MEETING NOTICE AND AGENDA
TECHNICAL ADVISORY COMMITTEE
OF THE
SEASIDE BASIN WATER MASTER

DATE: Wednesday, March 11, 2015

| <u>Agenda Item</u> | <u>Page No.</u> |
|---|-----------------|
| 3. Peer Review of HydroMetrics Laguna Seca Subarea Modeling Work | |
| A. Presentation of Draft Peer Review Technical Memorandum (Gus Yates) | 6 |

Figure 9
Hydrographs of
Sensitivity Results,
Northern Coastal Subarea

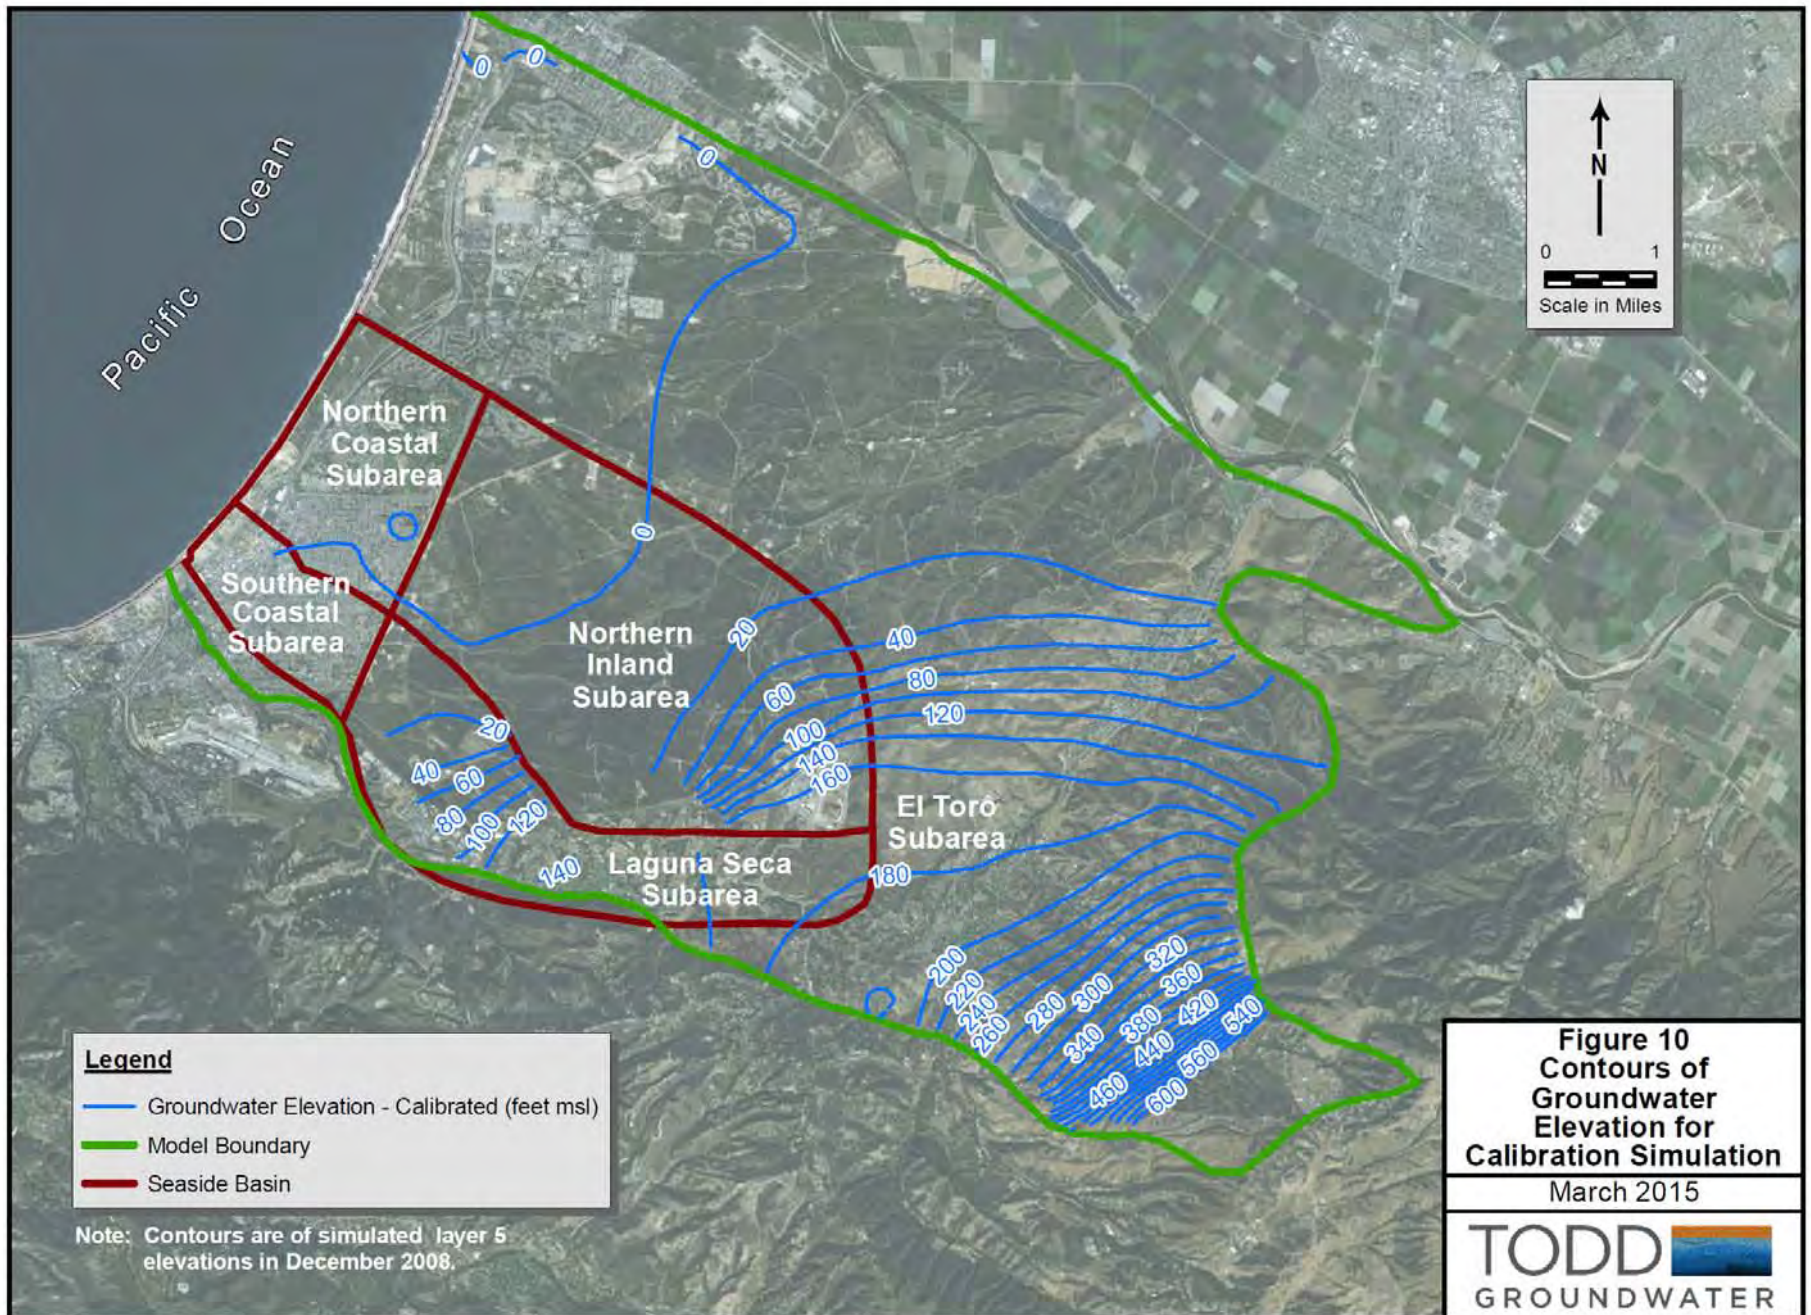
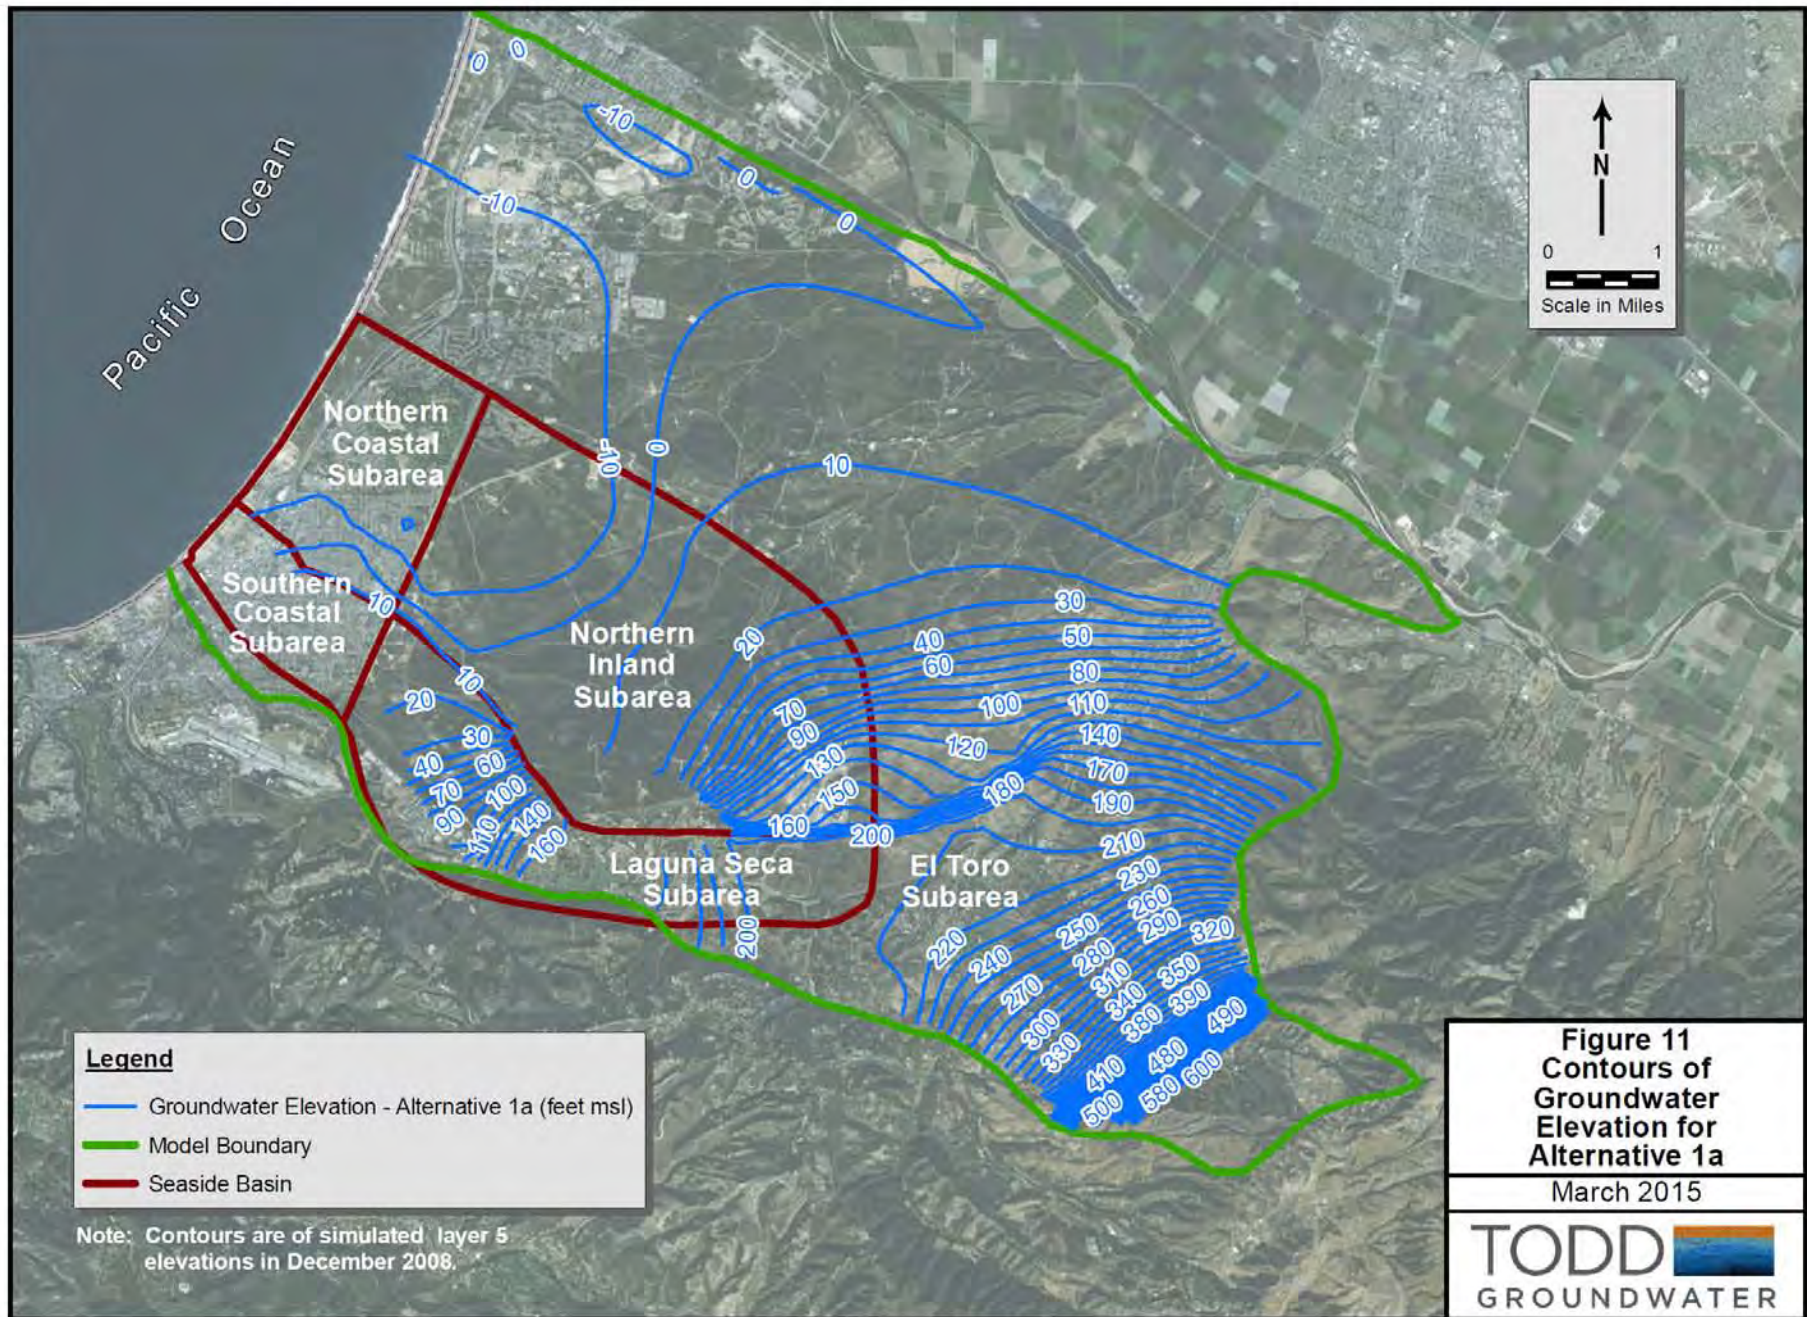
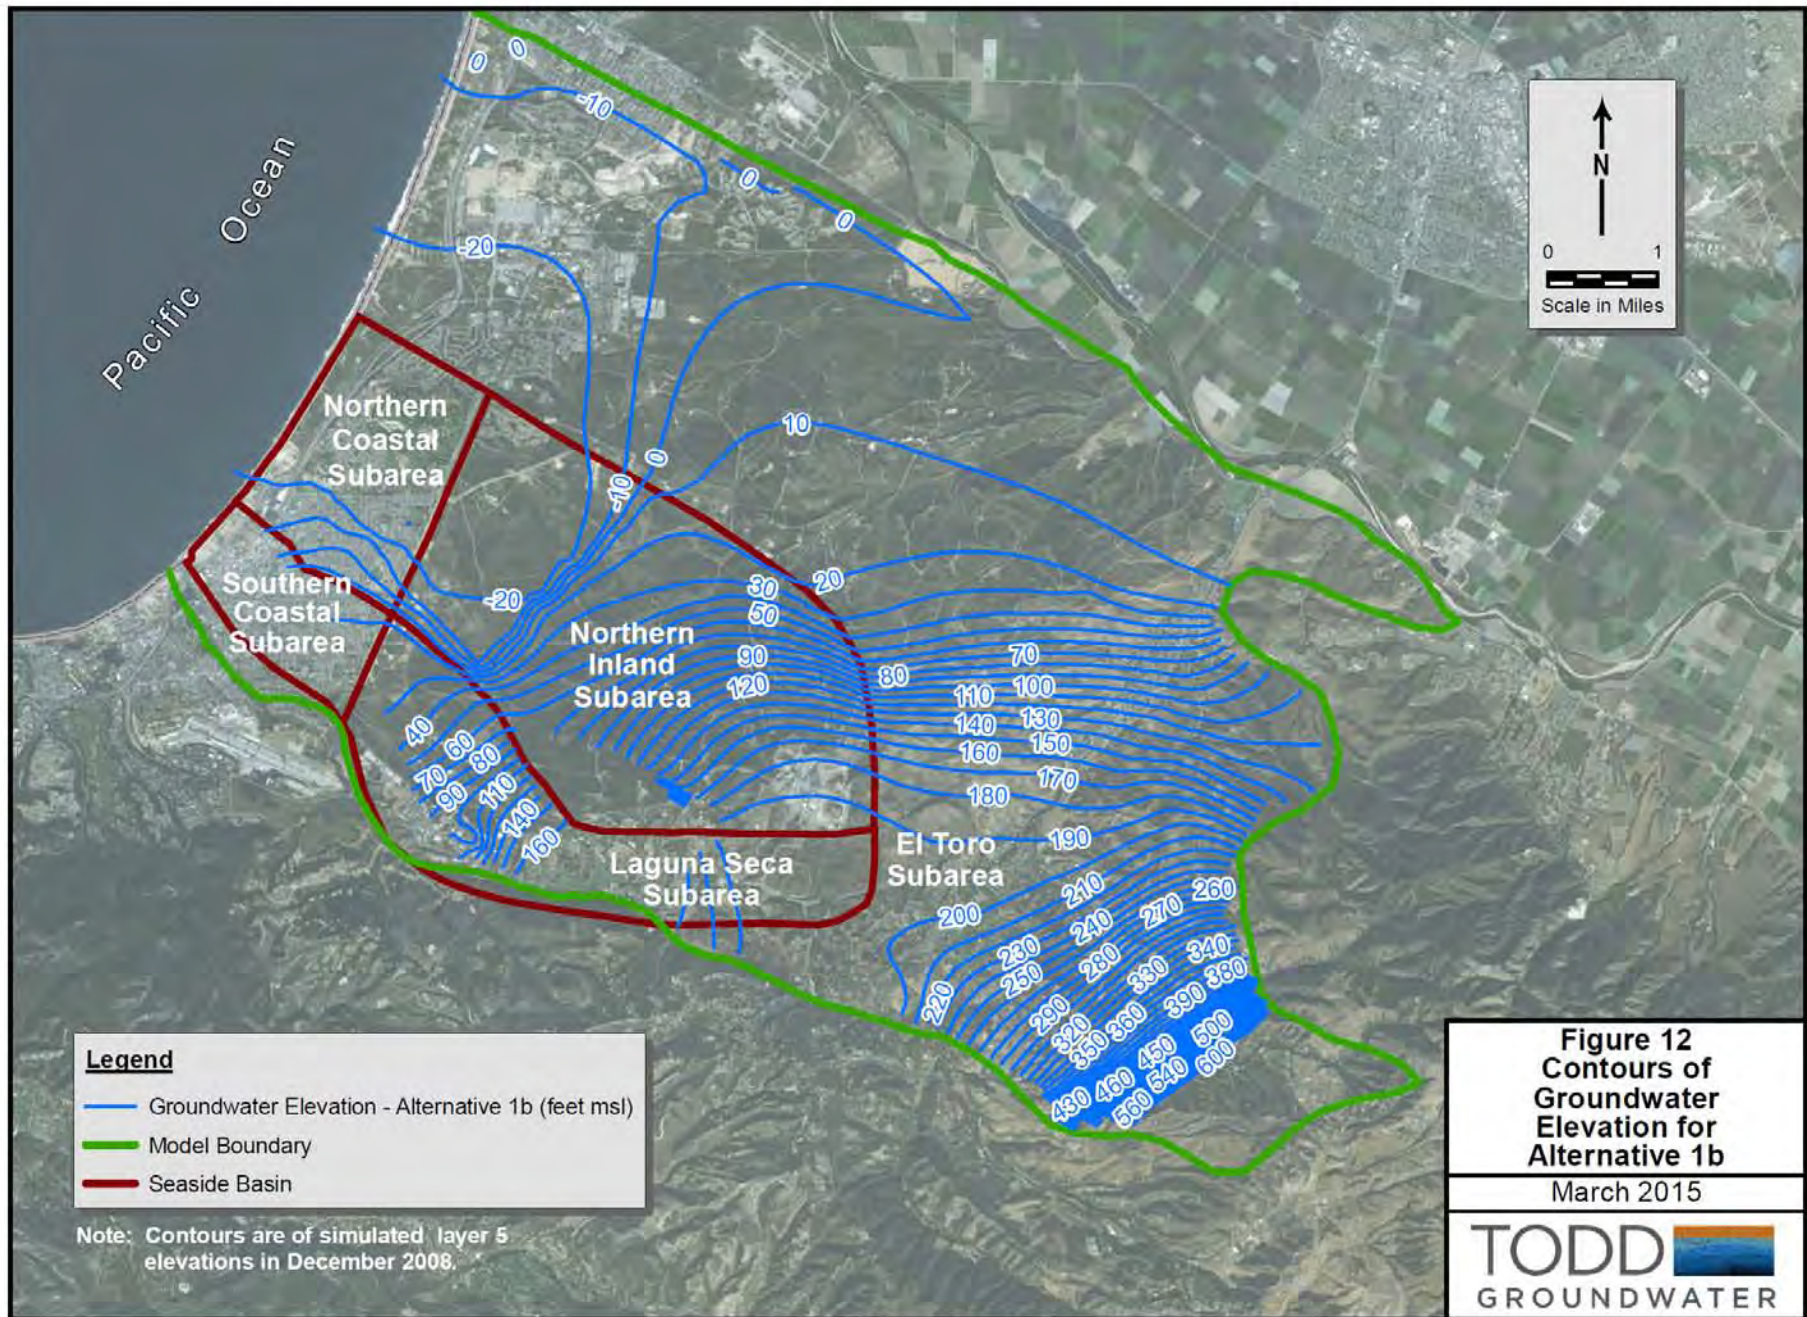
Hydrographs of selected wells are shown in **Figure 9** for the calibration simulation and the three sensitivity alternatives. The results for Alternatives 1a and 1b are slightly offset from the calibration hydrograph, but have the same slope. The long-term slope of the hydrograph is the principal indicator of basin yield. Because the slopes remained unchanged, the estimate of yield would not change. The hydrographs for Alternative 2 exhibit a different type of response. Initial water levels at the start of the simulation were much higher than the initial water levels in the calibration simulation. Over a period of about 20 years, they converged with the calibration hydrograph. This is the result of head-dependent boundary responses, which counteract perturbations that are inconsistent with inflows, outflows and aquifer parameters. Thus, the different hydrograph slope for Alternative 2 does not necessarily indicate a different estimate of subarea yield.

- Decreasing the rate of east-to-west flow across the Northern Inland Subarea did not result in simulation of a pumping trough in the Northern Coastal Subarea. Hydrographs in the Northern Coastal Subarea were shifted up or down slightly but had the same slopes as in the calibration simulation.
- In the Northern Coastal Subarea, the storage response in model layer 5 to decreased inflow from the east was the smallest of the five head-dependent boundary responses.
